51S-1/1F Receiver
SERVICE BULLETIN NO 6

EQUIPMENT: 51S-1 Receiver (522-2245-000)
51S-1F Receiver (522-2498-000)
(not valid for 51S-1A/1AF)

SUBJECT: Provision for high-speed receiver muting and recovery

51S-1/1F Modification Schematic Changes

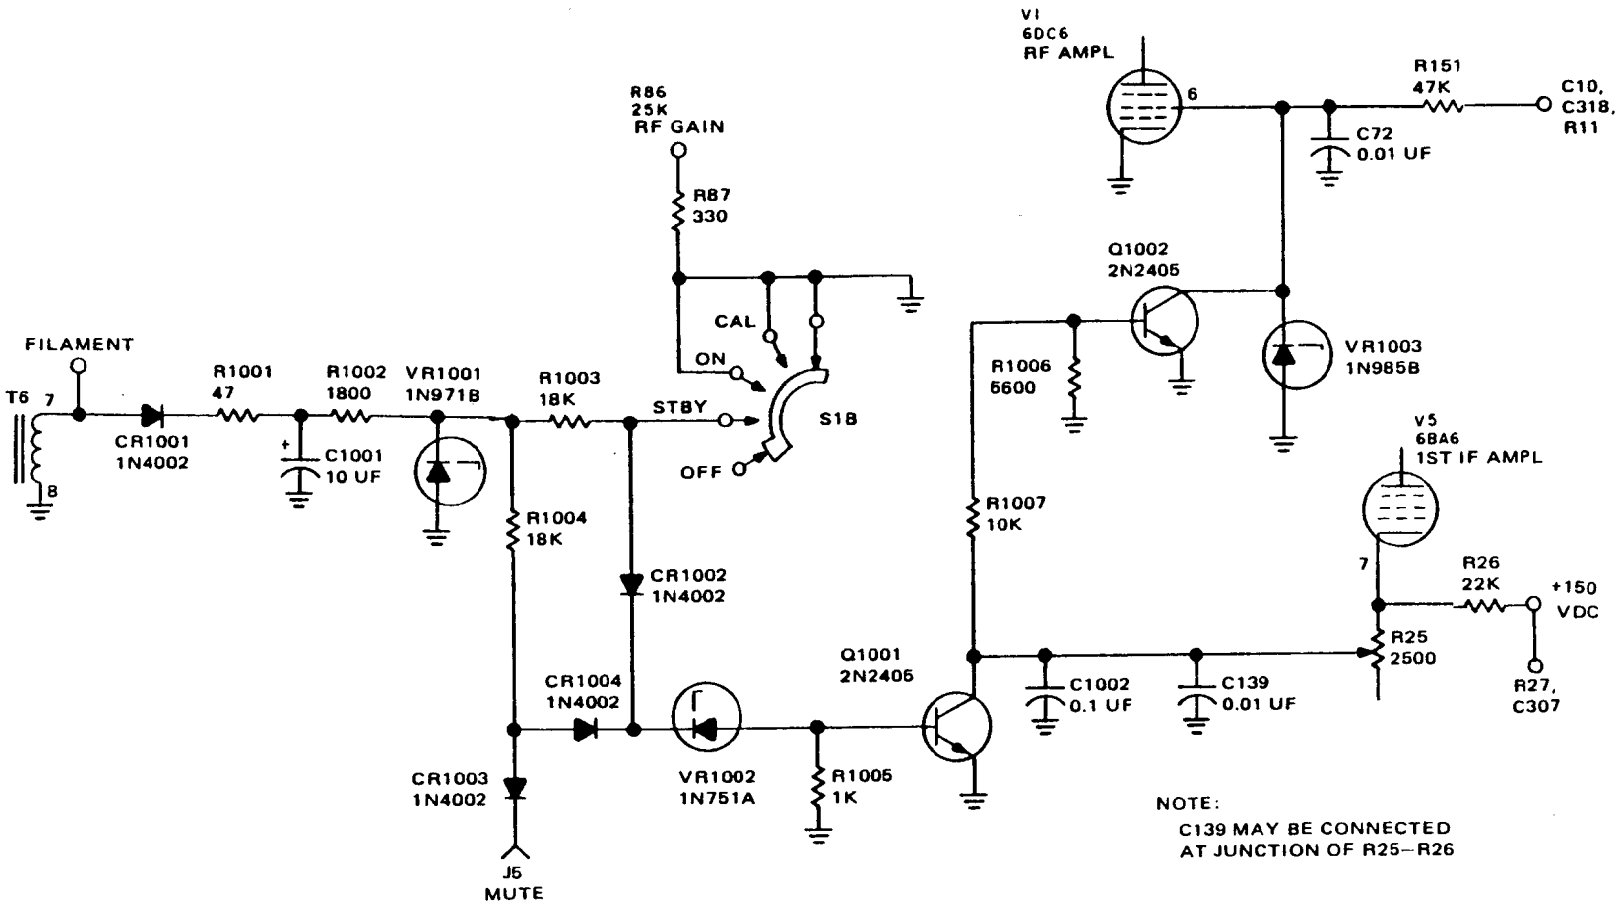
- b. Disconnect the wires from mute jack J5 (figure 6-3, page 6-14) and reattach them to a nearby ground post. Remove and discard 0.01 μ F capacitor C323.

- c. Remove the shield cover over the bottom of the 51S-1.
- d. Remove existing 47-k Ω , 1/2-watt resistor R151 (V1 screen-grid resistor), and replace with new 47-k Ω , 1-watt resistor (745-3422-000).

- e. Connect a #22 orange wire (439-3033-000) to XV1-6, route other end out of rf section at rear of chassis, and connect to TB6-B.
- f. Replace shield cover removed in step c.

- g. Connect 1N4002 diode CR1001 (353-6442-020) from T6-7 (anode end) to TB12-H (cathode/banded end).
- h. Connect 47-ohm, 1/4-watt resistor R1001 (745-0701-000) from TB12-H to TB12-C.

- i. Connect 1800-ohm, 1/4-watt resistor R1002 (745-0758-000) from TB12-C to TB12-D.
- j. Connect 10- μ F, 50-Vdc capacitor C1001 (183-1368-000) from TB12-C (+ end) to ground lug near TB12 toward rear of 51S-1 chassis (- end).

- k. Connect 1N971B diode VR1001 (353-3182-000) from TB12-D (cathode/banded end) to ground lug near TB12 toward rear of 51S-1 chassis (anode end).
- l. Connect 18-k Ω , 1/4-watt resistor R1004 (745-0794-000) from TB12-D to TB12-F.

- m. Connect 18-k Ω , 1/4-watt resistor R1003 (745-0794-000) from TB12-D to TB12-J.
- n. Connect 1N4002 diode CR1003 (353-6442-020) from TB12-F (anode end) to TB12-A (cathode/banded end).

- o. Connect 1N4002 diode CR1002 (353-6442-020) from TB12-J (anode end) to TB12-K (cathode/banded end).
- p. Connect 1N4002 diode CR1004 (353-6442-020) from TB12-F (anode end) to TB12-K (cathode/banded end).

- q. Connect 1N751A diode VR1002 (353-2710-000) from TB12-K (cathode/banded end) to TB12-L (anode end).
- r. Connect 1000-ohm, 1/4-watt resistor R1005 (745-0749-000) from TB12-L to ground lug near TB12 toward front of 51S-1 chassis.

- s. Connect 2N2405 transistor Q1001 (352-0479-000) to TB6-J (emitter), TB6-I (base), and TB6-H (collector).
- t. Connect #24 sleeved bus wire (428-4823-000) from TB12-L to TB6-I.

- u. Connect #24 bus wire (421-2420-000) from TB6-J to ground lug near TB12 toward front of 51S-1 chassis.
- v. Connect #24 bus wire (421-2420-000) from TB6-J to TB6-D.

- w. Connect 10-k Ω , 1-watt resistor R1007 (745-3394-000) from TB6-H to TB6-C.
- x. Connect 0.1 μ F capacitor C1002 (913-3681-000) from TB6-H to ground lug near TB12 toward front of 51S-1 chassis.

- y. Remove the bus wire presently connected from receiver gain resistor R25 to ground, and replace it with a #22 green wire (439-3034-000) from R25 (center terminal) to TB6-H.

- aa. Connect 560-ohm, 1/4-watt resistor R1006 (745-0740-000) from TB6-C to TB6-J.
- ab. Connect 2N2405 transistor Q1002 (352-0479-000) to TB6-D (emitter), TB6-C (base), and TB6-B (collector).

- ac. Connect 1N985B diode VR1003 (353-3196-000) from TB6-B (cathode/banded end) to TB6-D (anode end).
- ad. Connect a #22 brown wire (439-3036-001) from TB12-J to S1B-STBY (this wire is grounded by S1 when in the STBY position).

- ae. Connect a #22 blue wire (434-3035-000) from TB12-A to J5 mute jack S5.
- af. Turn the 51S-1 switch S1 to ON, and readjust receiver gain as explained in paragraph 4.4.11 of the instruction book.

NOTE: The illustration on page 6 is a 51S-1/1F partial schematic diagram showing the modification changes.
